THE FACTORY

APRIL 2021

PLANNING UPDATE FOR FACADES

OMA

1.1 Theatre Façade

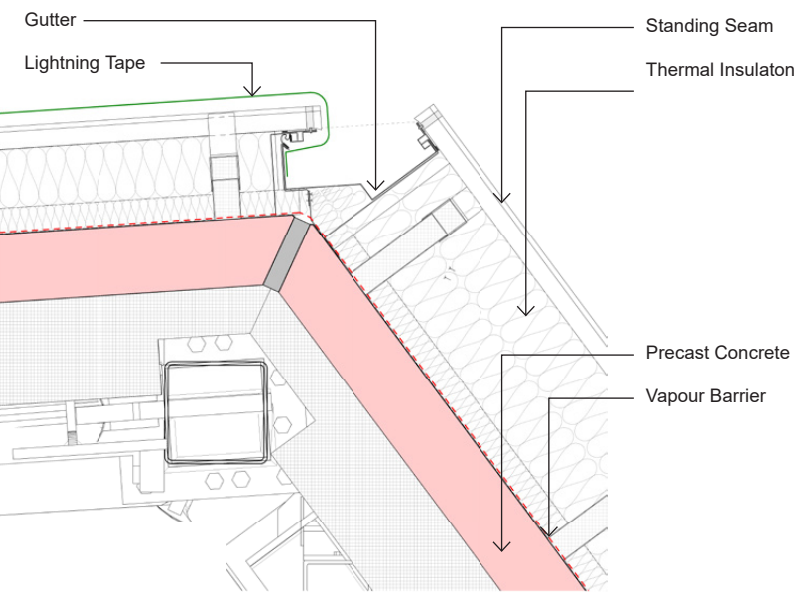
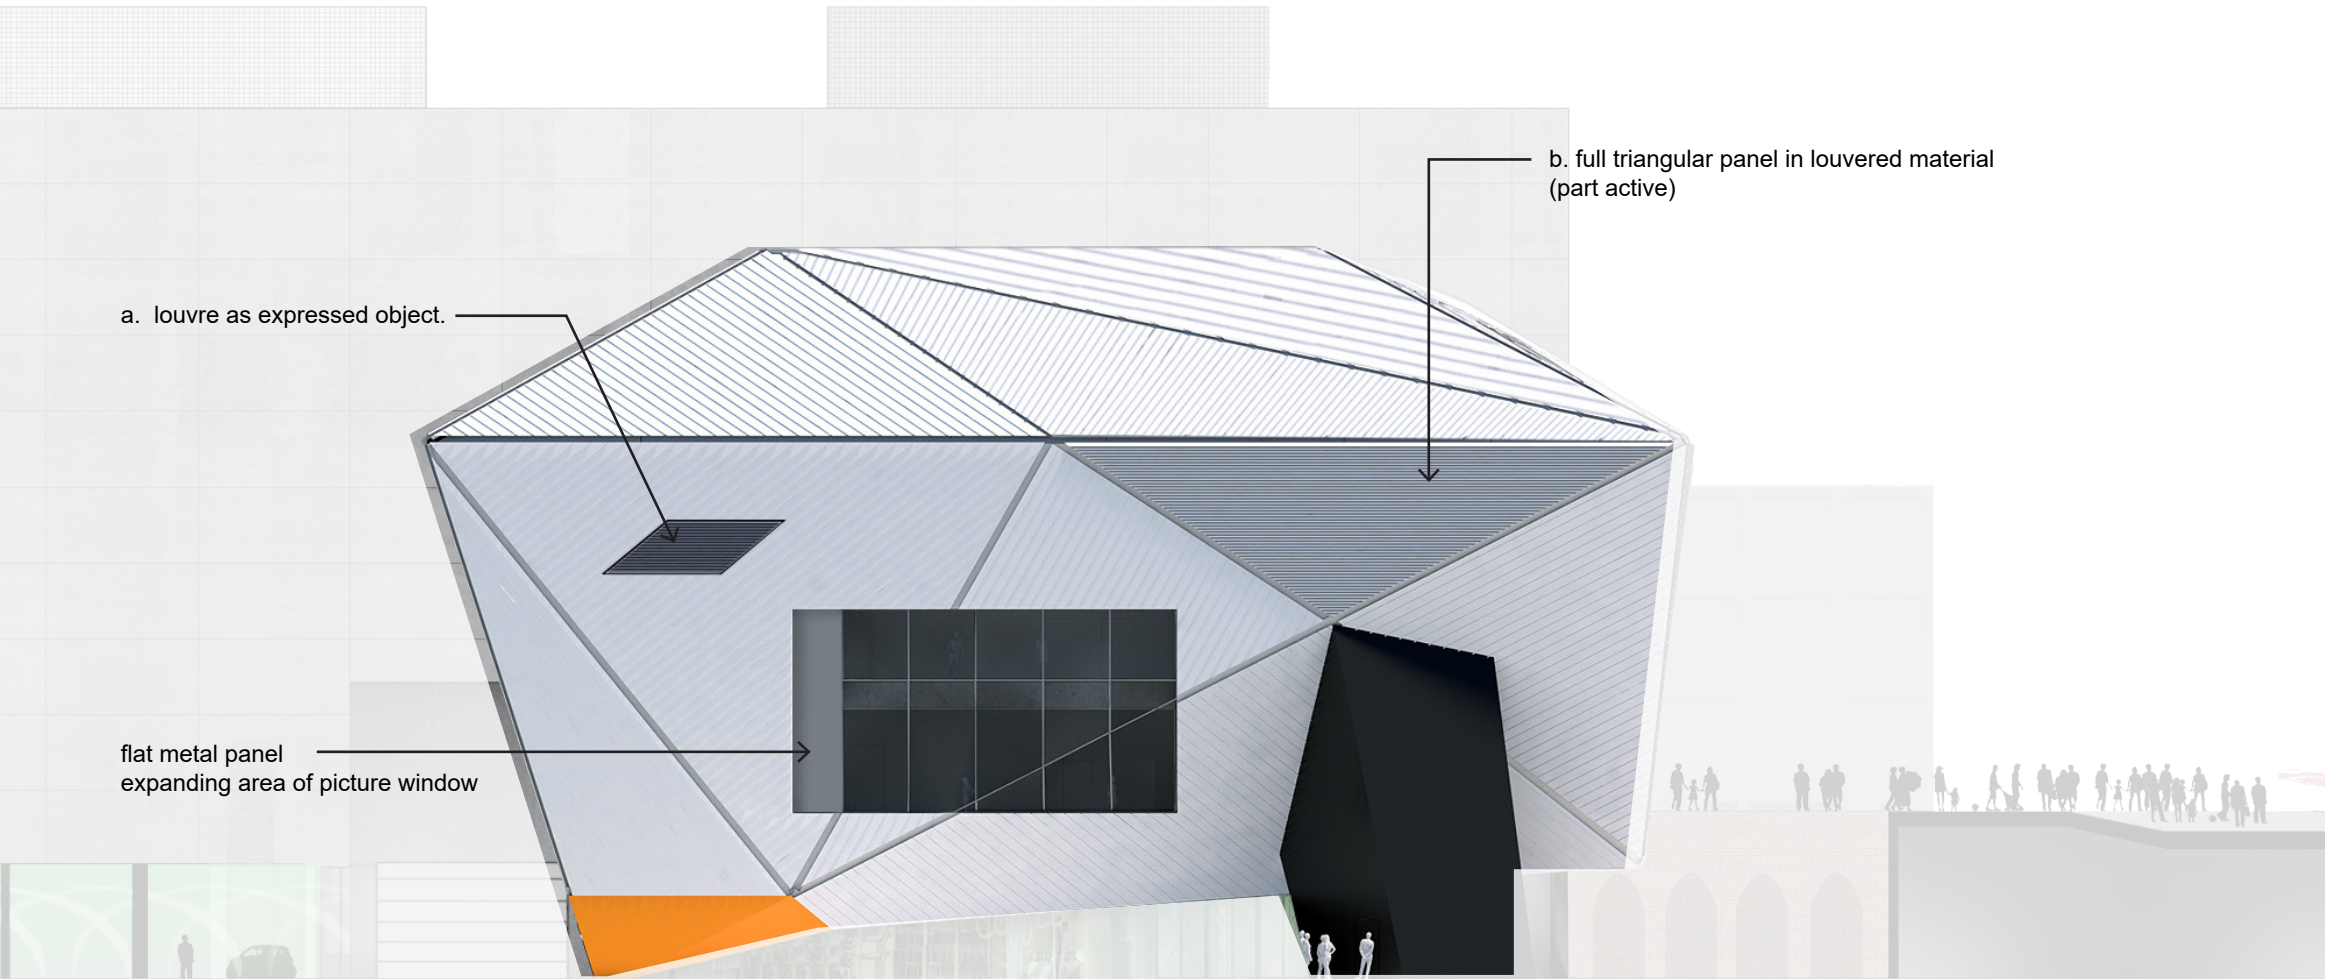
Through a process of design development, the materiality of the theatre façade has been revised from single-ply membrane to standing seam metal. This change was initially instigated through discussion with suppliers of single-ply membranes and related combustibility testing. Single ply membrane is a standard finish for building roofs, with fire classification to BS EN 13501-5 for the material in place for horizontal surfaces up to a slope of 70 degrees to the horizontal, considered a “roof.” Once the surface exceeds this slope, as at the lower portion of the theatre, is it considered a wall, and a different fire classification measurement is required to BS EN 13501-1. This “wall” fire classification and testing has not been undertaken for single ply membranes. Moreover, the manufacturers of such do not believe the material would pass the test, with an assumption that the surface spread of flame would move vertically. As such, replacement materials were considered: standing seam, GFRP panels, or rainscreen. .

The design team reviewed the potential cladding materials and propose the standing seam solution as illustrated. The seams on the material will produce shadow and can be rotated within the triangulated planes of the theatre to further emphasise its “jewel” like form. Some of the planes of the theatre shape have been further broken down to create an illusion of additional planes of crystallisation.

The ribbing of the material has been oriented as required for drainage. As previous, a white colour (powder coated) is proposed. The design team consider that the ribbing provides a natural camouflage for dirt, whereby water will flow at the valleys of the ribbing, which will emphasise the ribbed nature of the material.

Louvres have been further integrated and developed in detail design for MEP equipment located within the plantroom at the upper level of the theatre. These are compositionally

- expressed:
- a. as geometric “objects” within the overall elevation
 - b. as a full triangular plane

A powder coated flat aluminium panel has been added adjacent to the large picture window, expanding its visual expression.

Revised Cladding Proposal - natural concrete (Indicative Image)

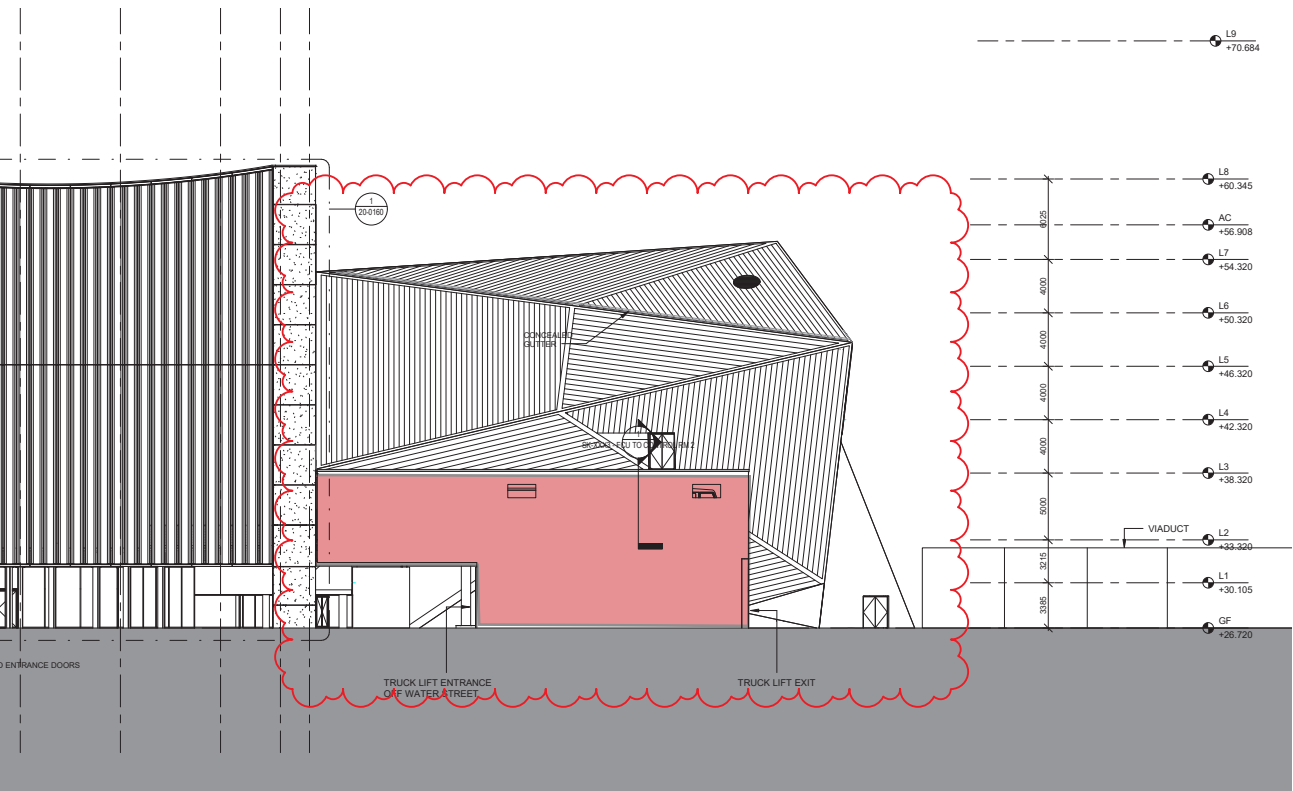
However, now that the shell has been built, the quality of the concrete is very good, and it is proposed that the over-cladding is unnecessary. Moreover, the expression of the truck lift in concrete is more in keeping with the overall concept for The Factory, as exactly that, a factory for the making of performance. The drama of the cantilever is best expressed in the material that is working to make it.

The concrete will be cleaned as part of the regular maintenance schedule, as with the warehouse concrete.

Decorative louvres in silver metallic will be utilised at the two ventilation openings at the upper line of the truck lift.

SOUTH ELEVATION

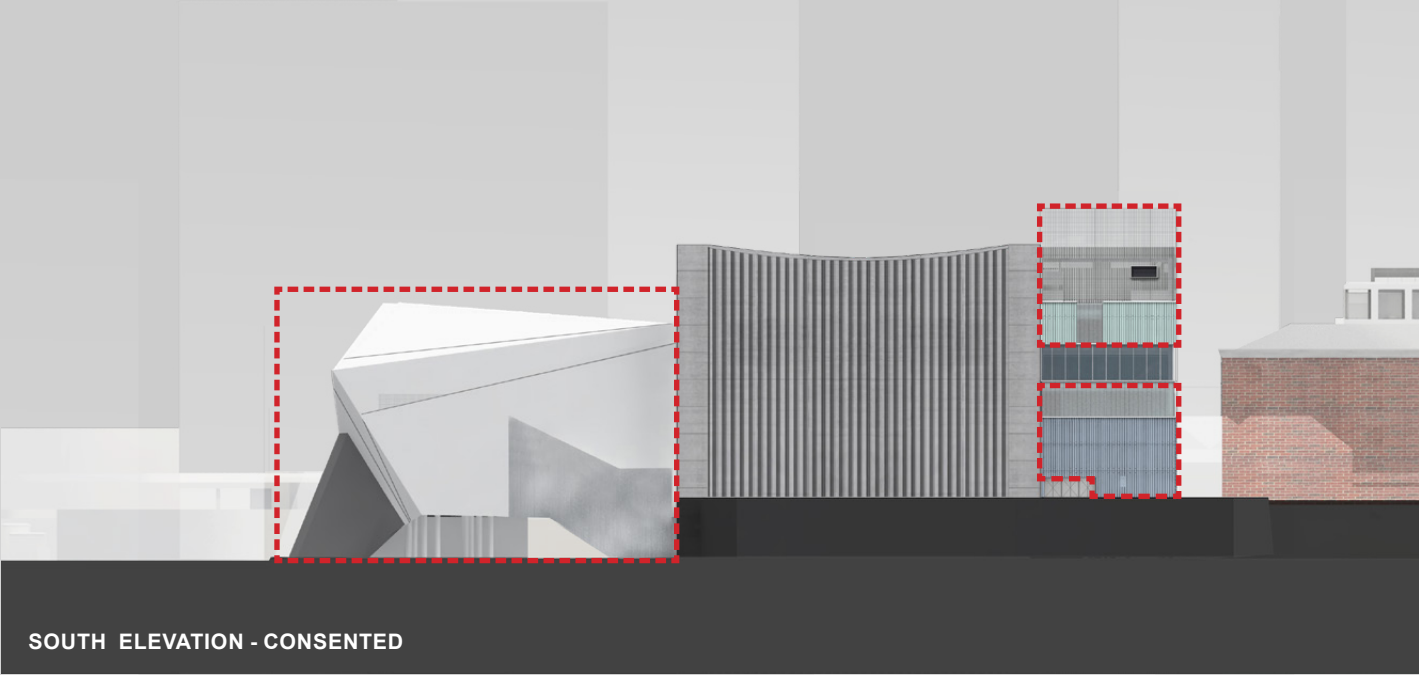
Showing re-orientation of the metal cladding and adjustment to windows at the Towers and the revised Theatre cladding.

EAST ELEVATION (ILLUSTRATIVE) - REVISED

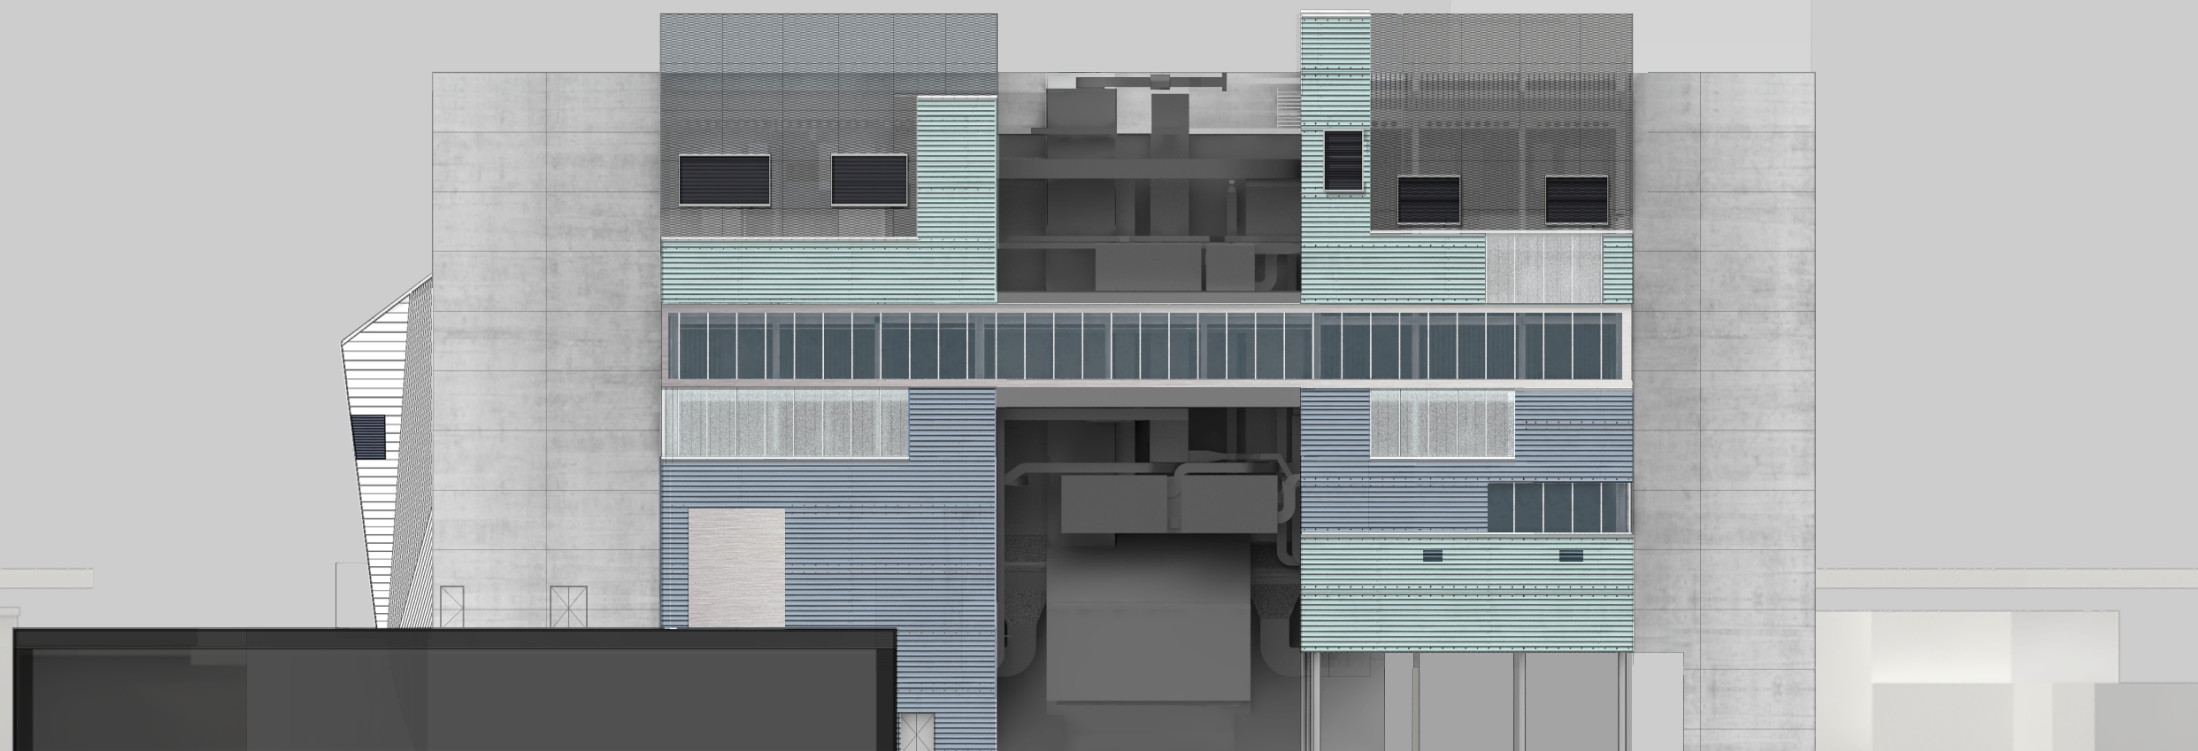
Showing re-orientation of the metal cladding and adjustment to windows at the Towers and the revised Theatre cladding where it is visible beyond the warehouse.

PROPOSED EAST ELEVATION

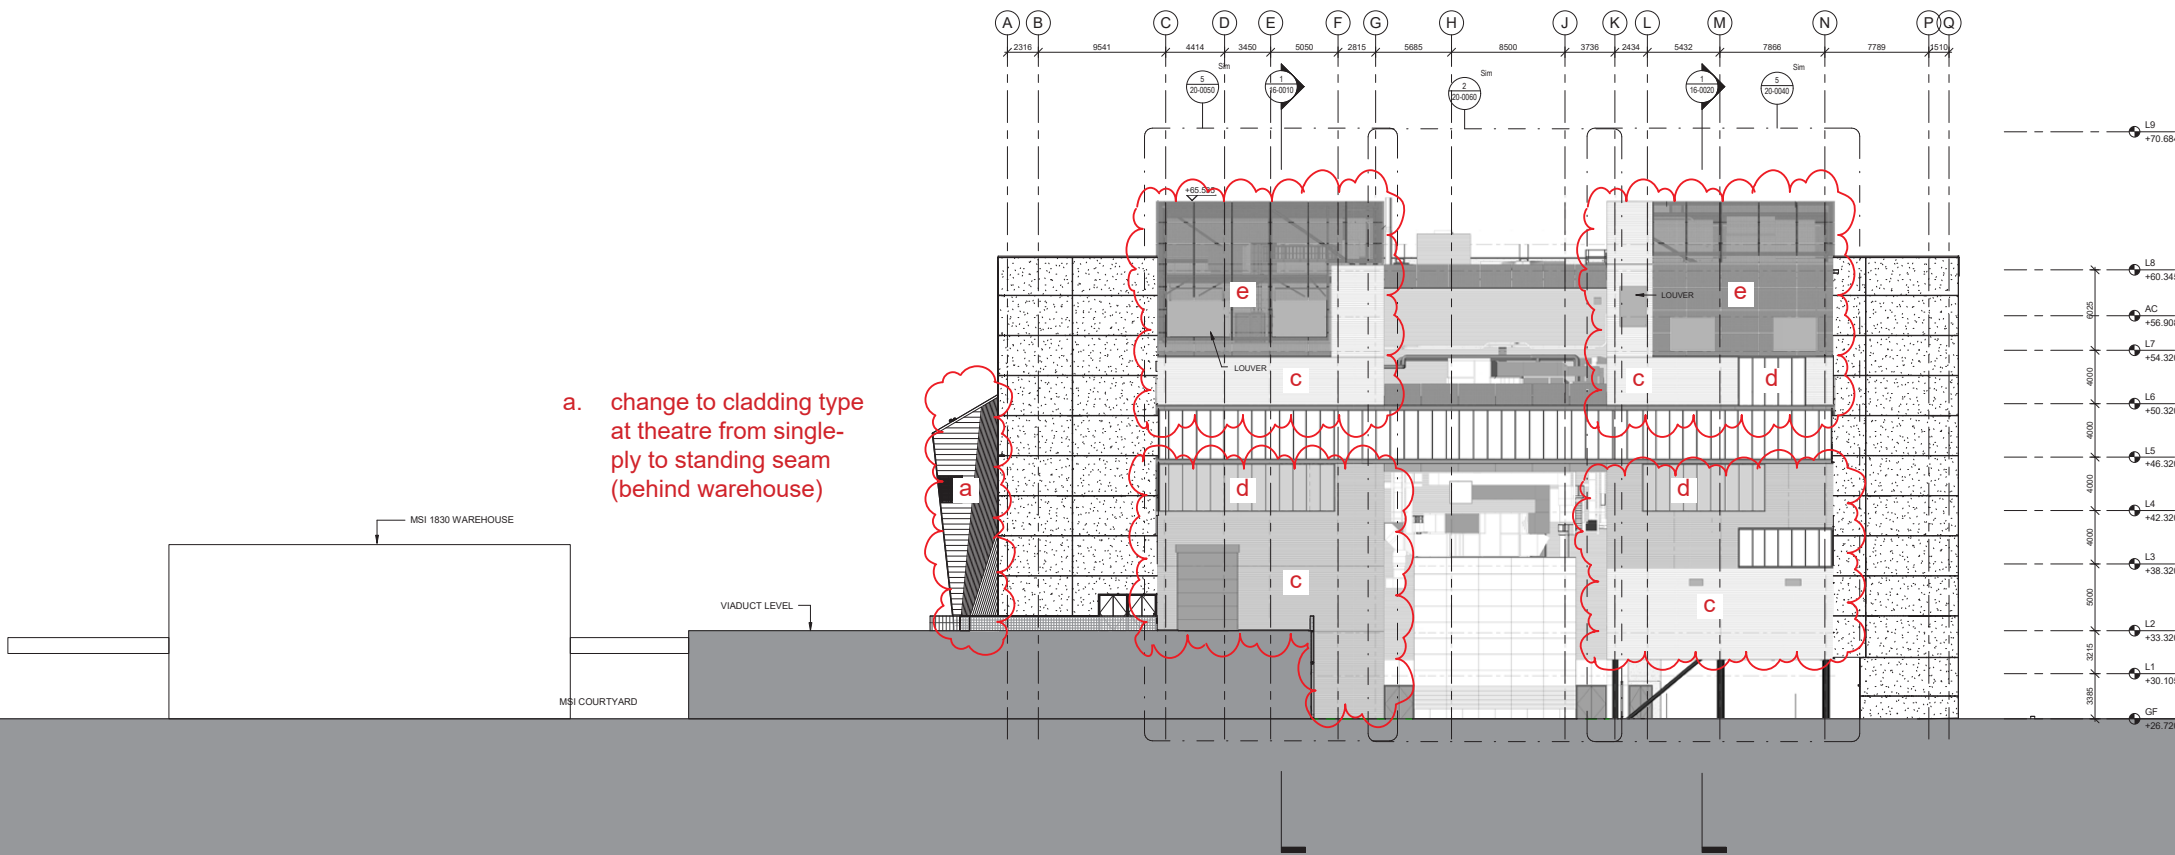
a. change to cladding type at theatre from single-ply to standing seam (behind warehouse)

- c. change from vertical to horizontal orientation of sinusoidal cladding
- d. change of channel glass to fritted translucent curtain wall
- e. change of metal mesh from elephant grid to expanded metal mesh

Theatre Envelope 3D views

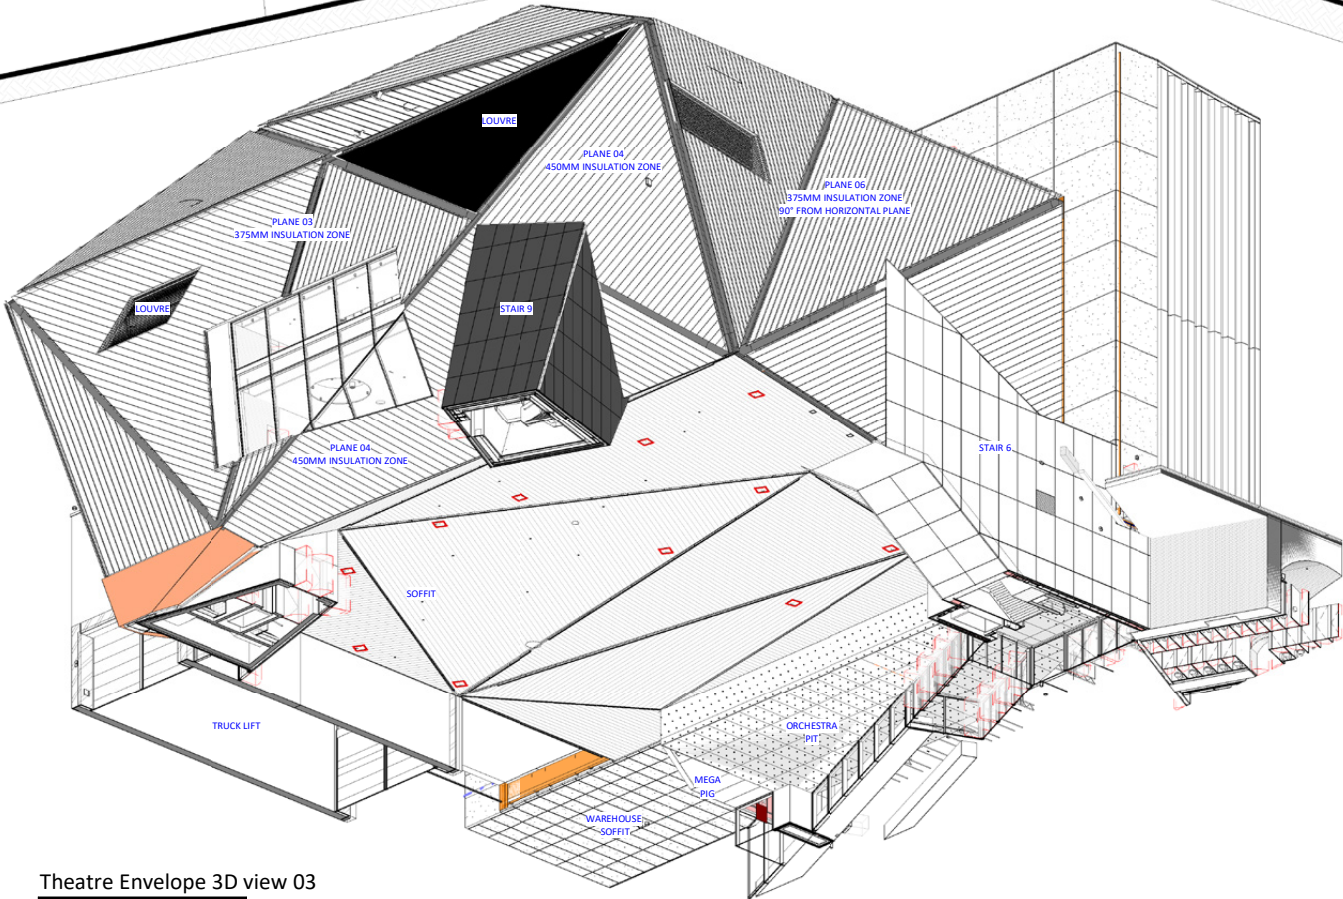
P03	Plane 02 standing seam directions updated.	SAY	LTA	11/03/2021
P02	Issued for Tender	SAY		11/01/2021
P01	Issued for Tender	GPIC	LTA	01/07/2020
Rev.	Description	Drawn	Checked	Date
